UNITED STATES PATENT AND TRADEMARK OFFICE

10/553,131

Office Action Summary	Application No. 10/553,131	Applicant(s) BARGHEER ET AL.	
	Examiner HELENA KOSANOVIC	Art Unit 3749

DETAILED ACTION

(fig. 2 of Gallup)

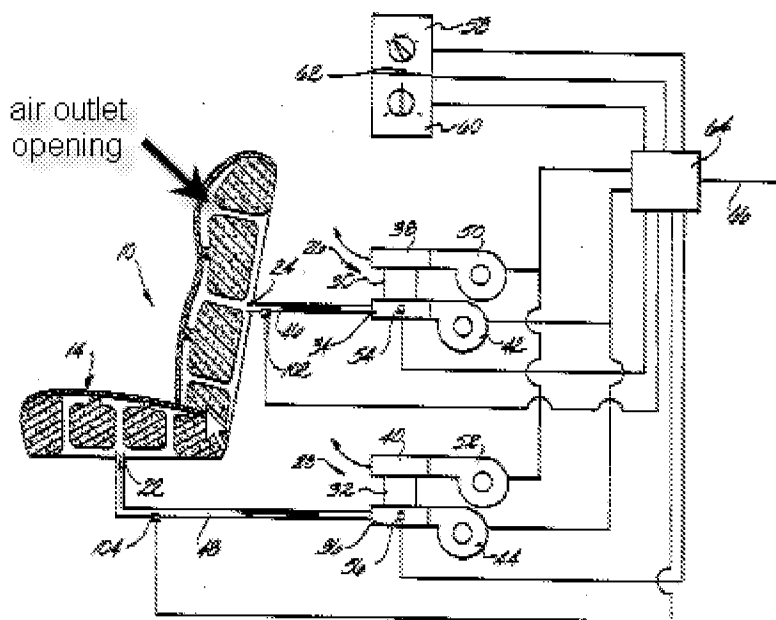
Regarding claim 8, an air supply device (fig. 2) for an automotive seat comprising: an air duct 46, which is arranged at the delivery side of a fan 42 and has at least one air outlet opening (see paragraph below where the examiner labeled originally not labeled elements with darkened arrow)provided in the upper region of the seat for supplying the head, shoulder and neck region of a seat occupant 12 with a flow of air, a heating element 34 arranged in the air duct between the fan and the air outlet opening, and at least one sensor 102 for detecting a parameter value as a function of which the flow of air emerging from the air outlet opening is controlled, wherein the sensor is arranged inside the air duct between (fig. 2) the air outlet opening and the heating element.

4. Examiner labeled originally not labeled elements with darkened arrow.

Regarding Applicant's argument that that fan 42 is not disposed in the lower end of the air supply device, the examiner disagrees. As shown in figure 2, fan 42 is disposed at the lower end of the air device 42, 34, 42. As is clearly shown in figure 2, fan 42 is on the lower end of said air device.

(fig. 2 of Brand)

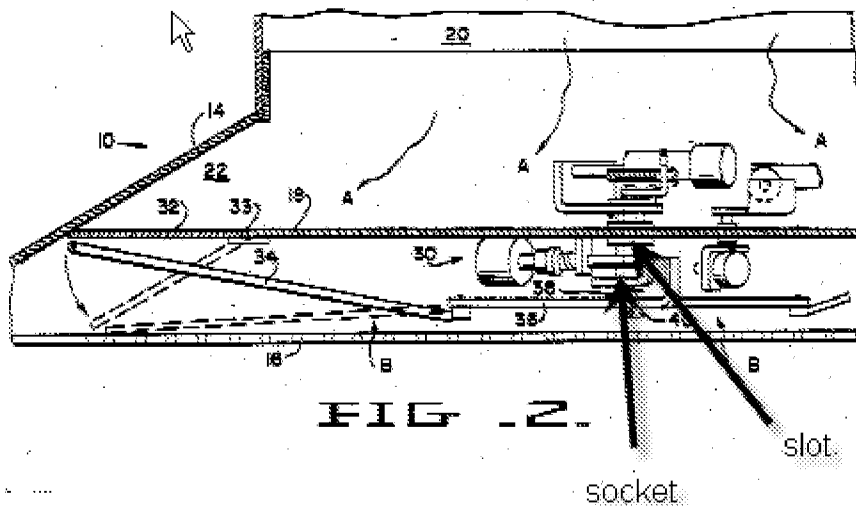
Brand teaches the sensor 30 (fig. 2) having a socket part (see paragraph below where the examiner labeled originally not labeled elements with darkened arrow) located in a slot (see paragraph below where the examiner labeled originally not labeled elements with darkened arrow).
